**KFO objection to
Notice of Intention to Designate
Porcupine Shelf and Southern Canyons SACs**

**Edward Farrell
Killybegs Fishermen's Organisation
Designated Areas Appeals Advisory Board (DAAAB)
Friday 14 March 2025**

KFO Appeal Report Outline

6c. Proposed Southern Canyons SAC – Additional Evidence

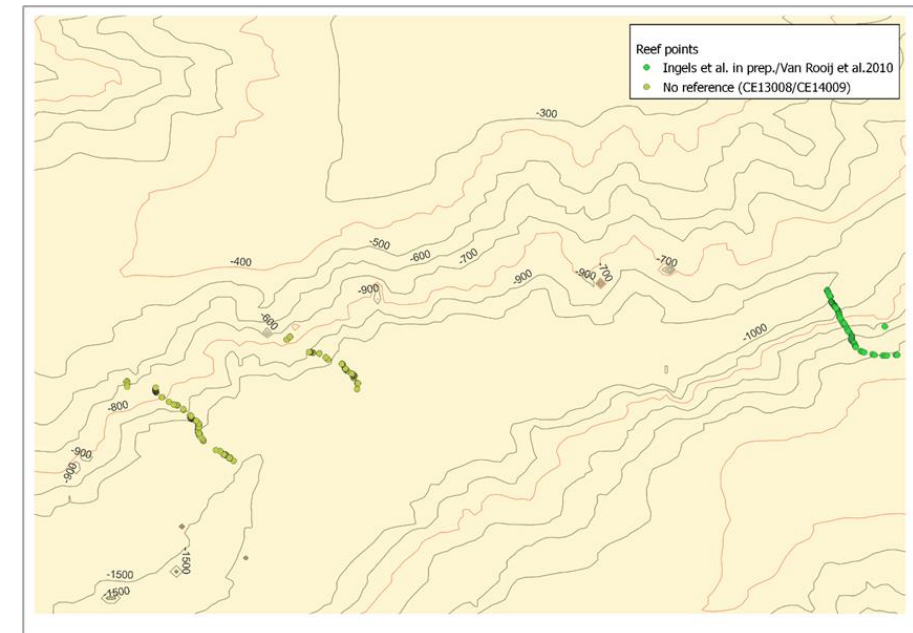
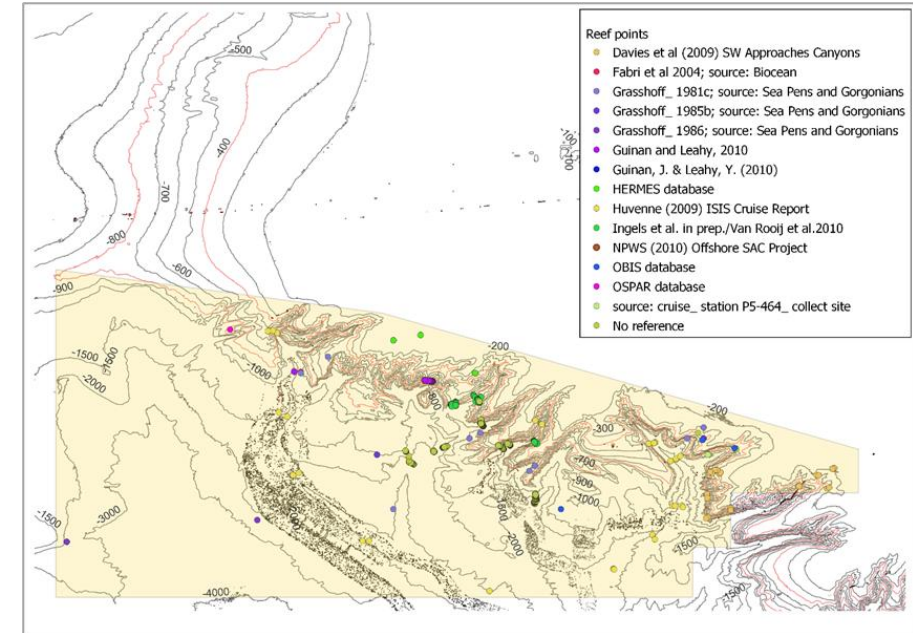
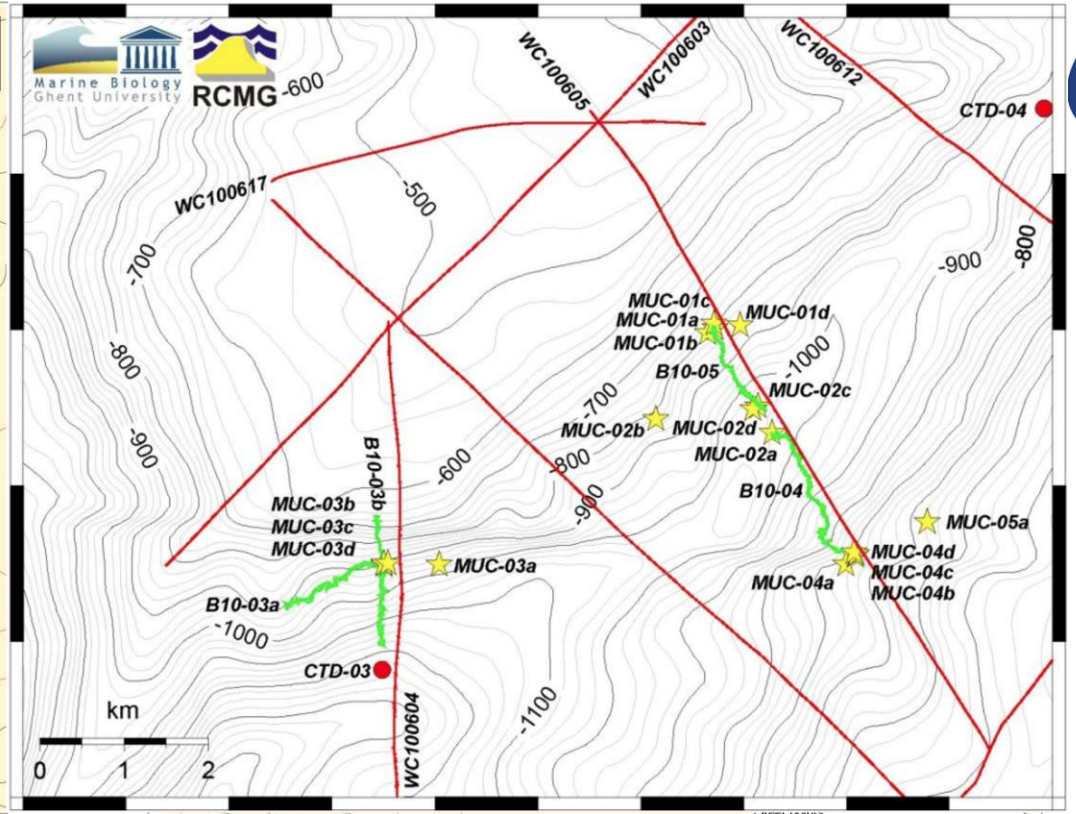
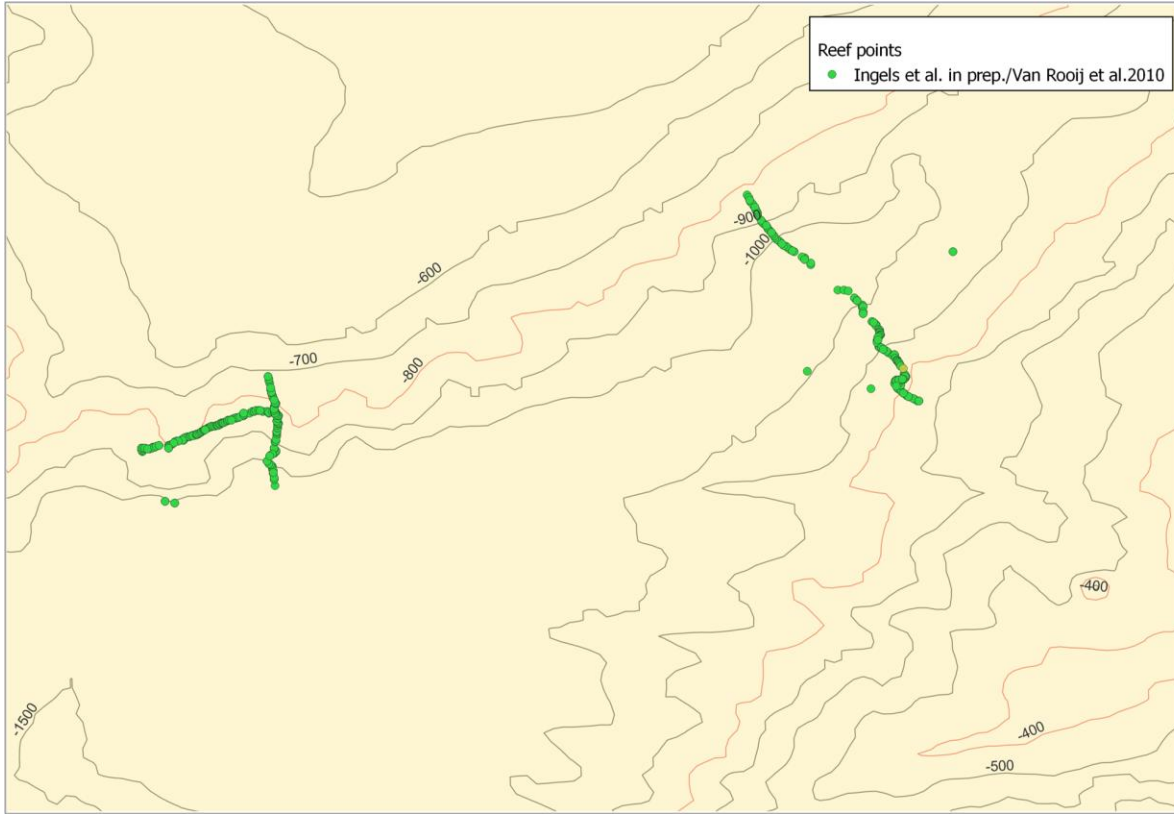
- **Reef Points – 15 sources**
 - 12 records <400m
 - No access to original sources
 - Duplicated records
 - Huvenne and Davies *et al.* both in *Reef polyline*
 - NPWS (2010) and Guinan & Leahy
 - Partial inclusion of records in some layers - Davies
 - Multiple points on single transect – 15,000 records?
 - Misrepresentation of data
 - Soft sediment classified as geogenic reef
 - ICES VME database errors (Grasshoff)
 - Unverified historical records – some from 1800s
 - Need for thorough review of all *Reef points* data

6c. Proposed Southern Canyons SAC – Additional Evidence

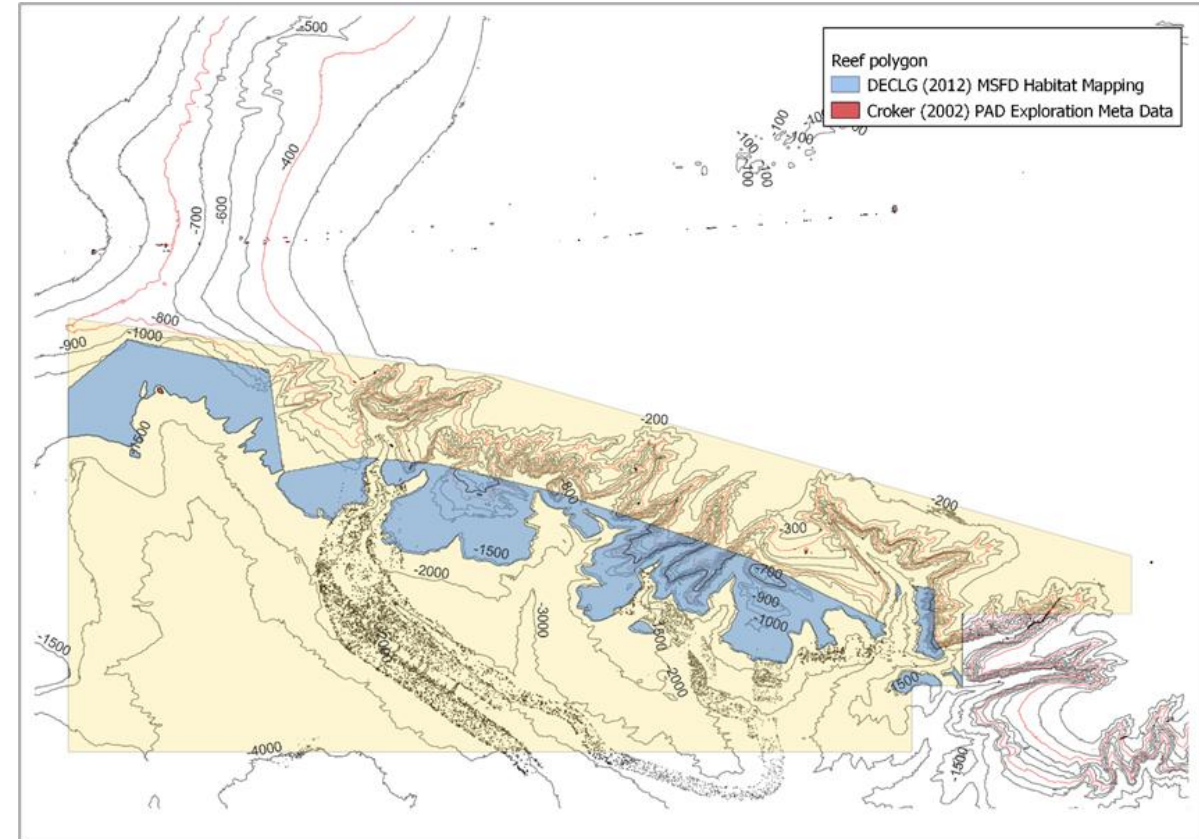
- *Reef Polygon* – 2 sources
 - Croker (2002) – single small polygon
- DECLG (2012) - MSFD Habitat mapping
 - Aligned with 1500m contour on deep side
 - Straight line on shallower side
 - No agreement with *Reef Points* layer
 - No explanation of the basis of this layer
 - No underlying data made available
